OVERCURRENT FUSE PROTECTION

Bulletin Type:	Safety Recall
Recall #:	19V-699 US 2019-502 CN
Job Code:	9902439
Flat Rate:	.4 Hour

Publication Date:	October 2019
Make:	Starcraft
Models:	Please note listing on last page of Instructions
Model Years:	2018-2019

Jayco - StarCraft Division - Recall US # 19V-699 CN # 2019-502

FIG B: Locate the 30A fuse at the front of the trailer.
Fuse is beside the junction box mounted to the ODS inner A-Frame rail.

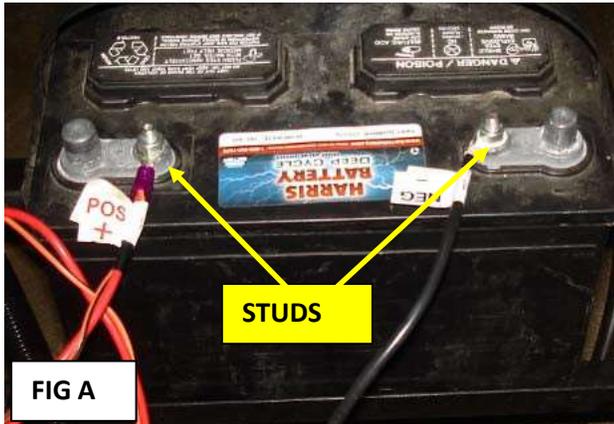
Pull the 30A fuse out of the fuse holder at the front of the trailer (**Fig 2**).

FIG 1:

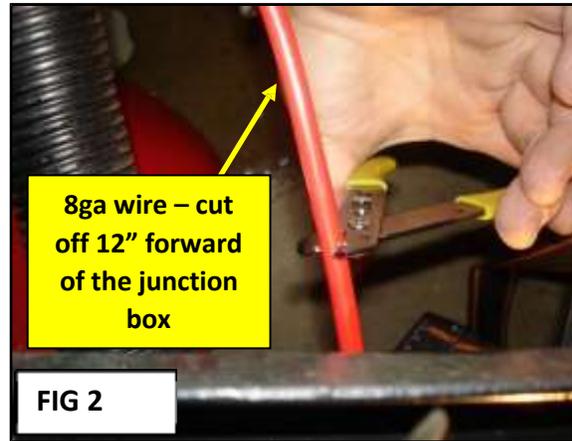
- Pull the red 8ga battery wire (coming directly from the battery) out of the large loom running along the A-frame.
- This would be near the 12-volt junction box mounted on the ODS inner rail of the A-frame.

FIG 2:

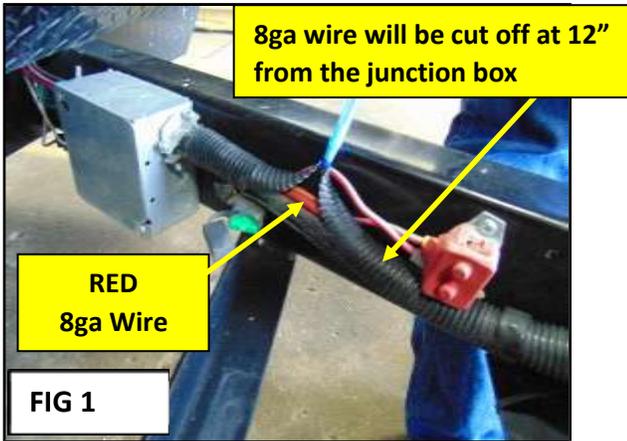
- Cut off this 8ga battery wire approximately 12" forward from where it enters the 12-volt junction box.

FIG 3:

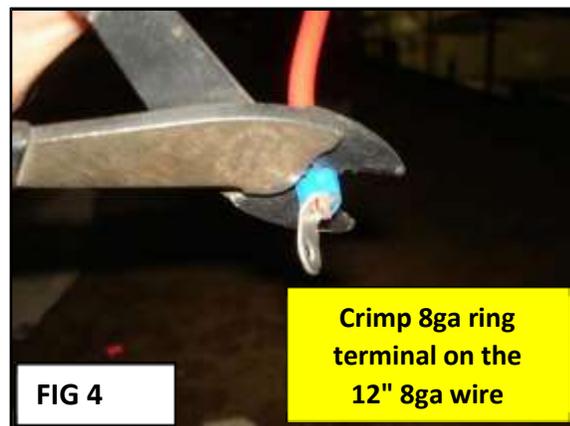
- Strip 5/16" from the 12" piece of 8ga wire coming out of the 12-volt junction box.

FIG 4:

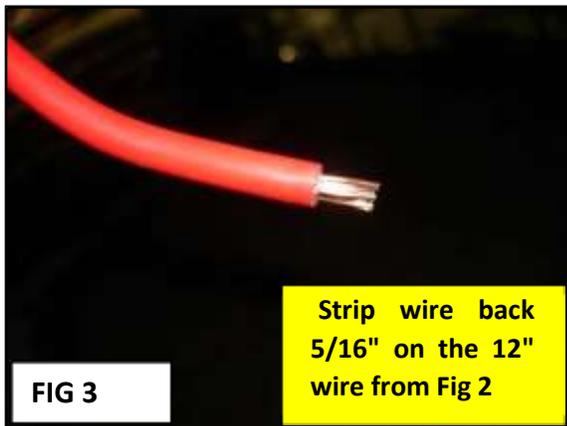
- Crimp the 8ga ring terminal from the kit to the stripped end of the 8ga wire.

FIG 5:

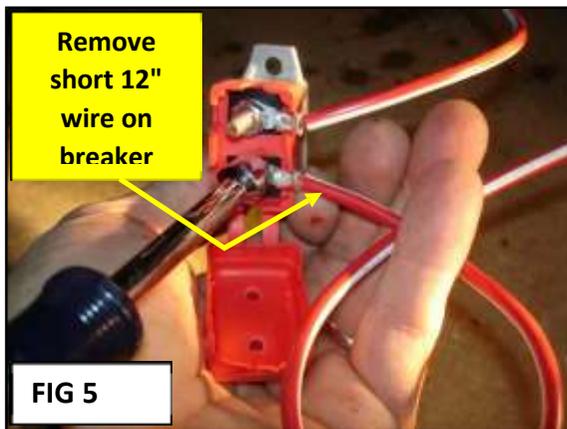
- Remove the short red/white stripe (12" wire that comes with the kit harness) from the silver stud on breaker and discard it.
- Use a 3/8" nut driver (or socket).

- Install the 8ga wire with the 8ga ring terminal to the silver stud on the circuit breaker.
- Tighten the nut with the 3/8" nut driver (or socket).

FIG 7:

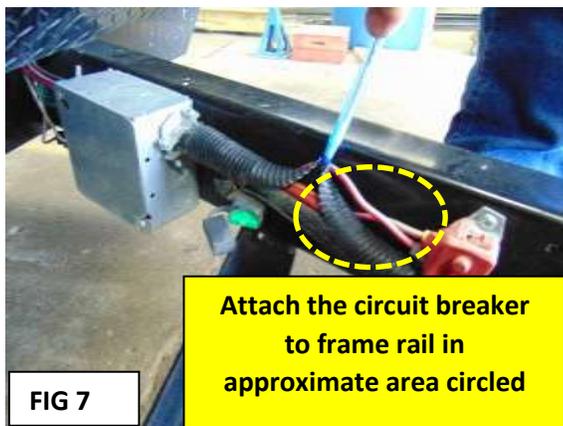
- Attach the circuit breaker to the ODS A-frame side rail (circled) using two 3/4" screws from kit.
- Breaker will need to be located within 12" of the junction box so the 8ga wire will reach.
- Put the rubber cap over the breaker studs.

- Red/white (48") wire feeds down into the loom and up to the positive battery post.
- The large ring terminal on the 48" wire attaches to the positive battery post.
- Pull out the remaining piece of the 8ga red wire (still in the loom from **Fig 2**) and discard it.

FIG 9:

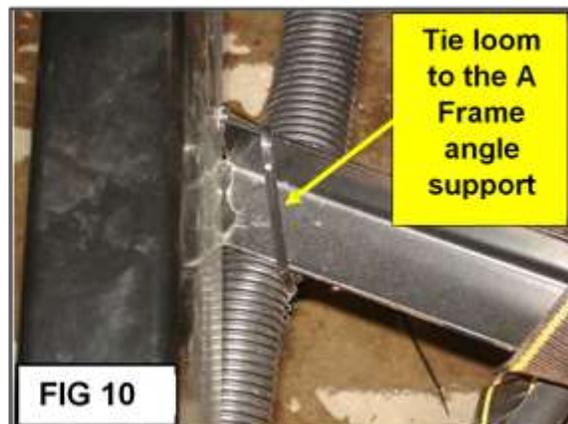
- Attach wire ties to close the harness

FIG 10:

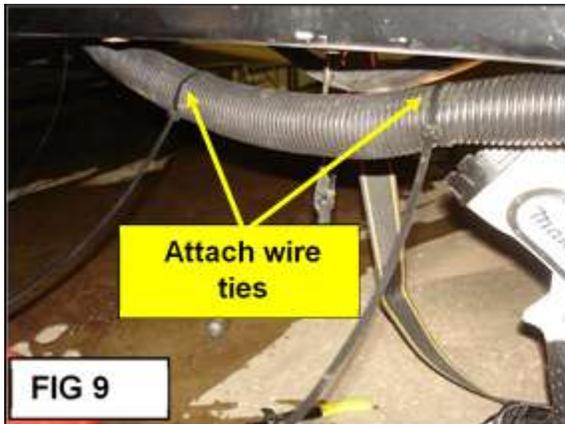
- Tie the loom to the angle support of the A Frame.
